UNITED STATES PATENT AND TRADEMARK OFFICE

APPLICATION NO.	FILING DATE	FIRST NAMED INVENTOR	ATTORNEY DOCKET NO.	CONFIRMATION NO.
10/587,145	07/10/2007	Rene Koerber	KORB3001/EJD	4988
23364 7590 11/09/2010 BACON & THOMAS, PLLC 625 SLATERS LANE FOURTH FLOOR ALEXANDRIA, VA 22314-1176				
EXAMINER VOLZ, ELIZABETH J				
ART UNIT 3781		PAPER NUMBER		
MAIL DATE 11/09/2010		DELIVERY MODE PAPER

Office Action Summary

DETAILED ACTION

Figure 1 (Reutter)

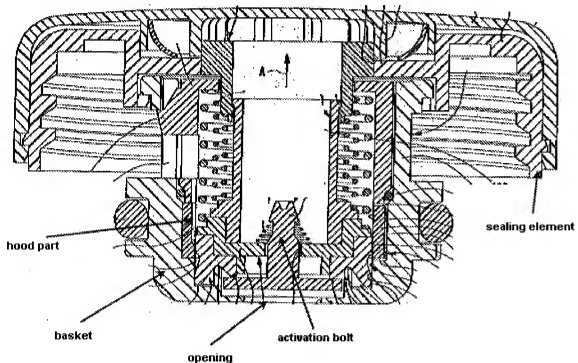
8. Claims 18-27 and 29-34 are rejected under 35 U.S.C. 102(b) as being anticipated by Reutter (U.S. Pub. No. 2003/0183632).
9. Regarding Claim 18, Reutter discloses an anti-twist device for a sealing cap, mountable or mounted on a fixed connecting piece of a container, in particular a motor

vehicle radiator (Paragraph 19), said sealing cap having: an external cap part 110 (Figure 1) with a grip element 112 (Figure 1) and with a sealing element (Figure 1 below) that is connectable to a counterpart sealing element of the connecting piece (Figure 1 below), relative to which sealing element said grip element is kept relatively rotatable; an internal cap part 114 (Figure 1) with a valve assembly 115 (Figure 1) embodied preferably as an excess/negative pressure combination; an anti-twist stop 180 (Figure 1) and in the external cap part which acts between said grip element and said sealing element; and a drive 171 (Figure 1) triggered by the operating data in the container, the drive being accommodated inside the container near the external cap part and serving to actuate said anti-twist stop (Figure 1).

10. Regarding Claim 19, Reutter discloses a drive has a drive part 172 (Figure 1), disposed on a circumferential region of a container wall adjacent to the connecting piece (Figure 1).

11. Regarding Claim 20, Reutter discloses a drive which is formed by two or more drive parts, distributed preferably uniformly over the circumference of a container wall adjacent to said fixed connecting piece (Figure 1).

12. Regarding Claim 21, Reutter discloses each of two drive parts is disposed, held separately, inside the container and tangentially below said counterpart sealing element of the connecting piece (Figure 1).

13. Regarding Claim 22, Reutter discloses each drive part is received in a housing (Figure 1 above) that is held suspended from the container wall.
14. Regarding Claim 23, Reutter discloses said housing is held in pressure tight fashion in a recess in the container wall (Figure 1).

15. Regarding Claim 24, Reutter discloses said housing is composed of a hood part (Figure 1 above), protruding from the container wall, and a basket part (Figure 1 above), whose bottom is provided with an opening (Figure 1 above).

16. Regarding Claim 25, Reutter discloses a hood part (Figure 1 above) which is provided with an axial lead through, which penetrates the container wall and is held in it in pressure tight fashion (Figure 1).

17. Regarding Claim 26, Reutter discloses a hood part and said basket part are joined, locking over and in one another (Figure 1).

18. Regarding Claim 27, Reutter discloses each drive part has a vertically oriented actuation bolt (Figure 1 above), which, facing toward said anti-twist stop, penetrates the container wall (Figure 1).

19. Regarding Claim 29, Reutter discloses a drive part which is pressure-controlled, and its actuation bolt is spring-loaded 167 (Figure 1) in the opposite direction.

20. Regarding Claim 30, Reutter discloses an anti-twist stop 180 (Figure 1) which has a horizontally disposed and axially movable coupling unit (Figure 1).

21. Regarding Claim 31, Reutter discloses a coupling unit has a number of separate coupling elements, corresponding to the number of drive parts, which coupling elements are each diametrically opposite said drive part or drive parts (Figure 1).

22. Regarding Claim 32, Reutter discloses a coupling element which is joined in a manner fixed against relative motion to an axial bolt 147 (Figure 1), which can be acted upon by said actuation bolt counter to the action of a compression spring 183 (Figure 1).

24. Regarding Claim 34, Reutter discloses a unit comprising a container having one of: a connecting piece, and a container connecting piece (Paragraph 19) and a sealing cap 111 (Figure 1), having an anti-twist device 180 (Figure 1; Paragraph 19), said

sealing cap having: an external cap part 110 (Figure 1) with a grip element 112 (Figure 1) and with a sealing element (Figure 1 above) that is connectable to a counterpart sealing element of the connecting piece (Figure 1), relative to which sealing element said grip element is kept relatively rotatable; an internal cap part 114 (Figure 1) with a valve assembly 115 (Figure 1) embodied preferably as an excess/negative pressure combination; an anti-twist stop 180 (Figure 1) and in the external cap part which acts between said grip element and said sealing element; and a drive 171 (Figure 1) triggered by the operating data in the container, the drive being accommodated inside the container near the external cap part and serving to actuate said anti-twist stop (Figure 1).
